Uniform provisions concerning the approval of motor vehicles with regard to the Advanced Emergency Braking System (AEBS) for M₂, M₃, N₂ and N₃ vehicles

Industry draft proposals with purple text (AEBS-05)

Industry input for deadline 14 September 2021

Figure 1:
Left turn or right turn at the intersection

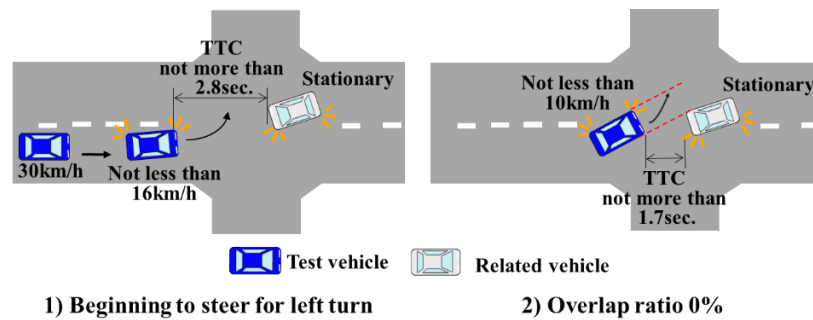
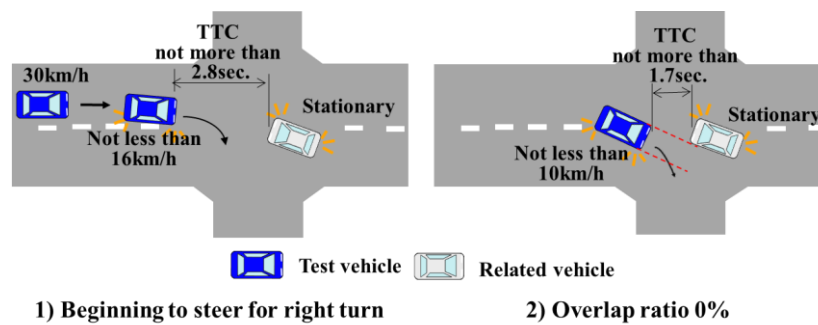
The blue car needs to be changed from passenger vehicle to large vehicle.

Figure 2:
Right turn or left turn of a forward vehicle

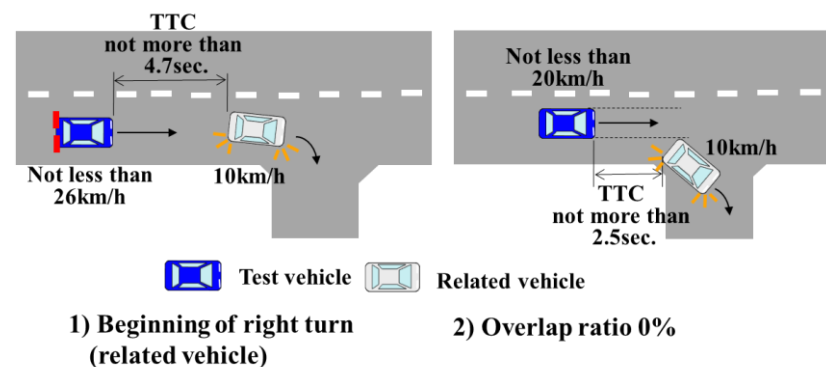
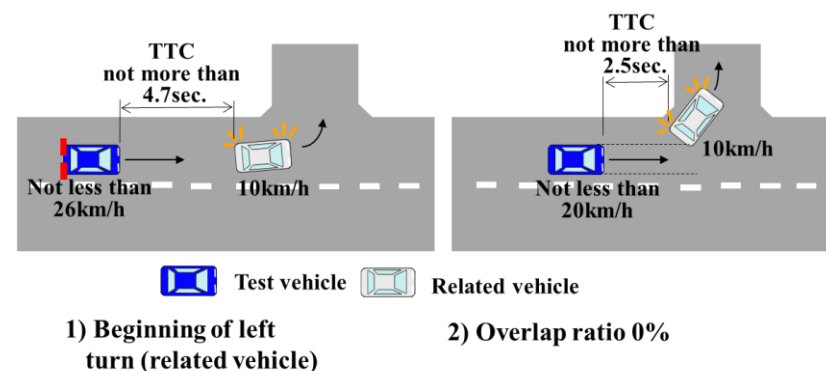
The blue car needs to be changed from passenger vehicle to large vehicle.

Figure 4:
Lane change due to road construction

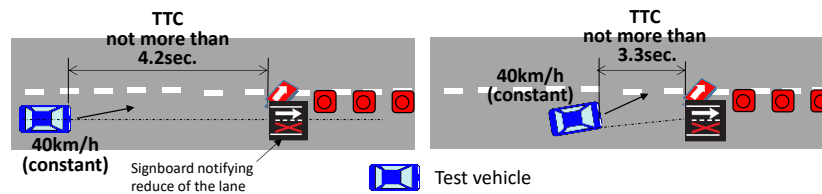
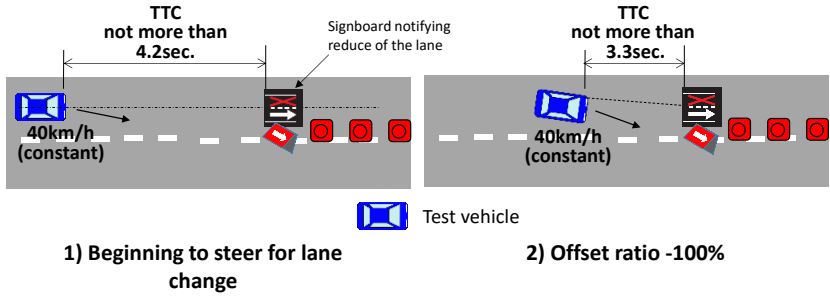
The blue car needs to be changed from passenger vehicle to large vehicle.
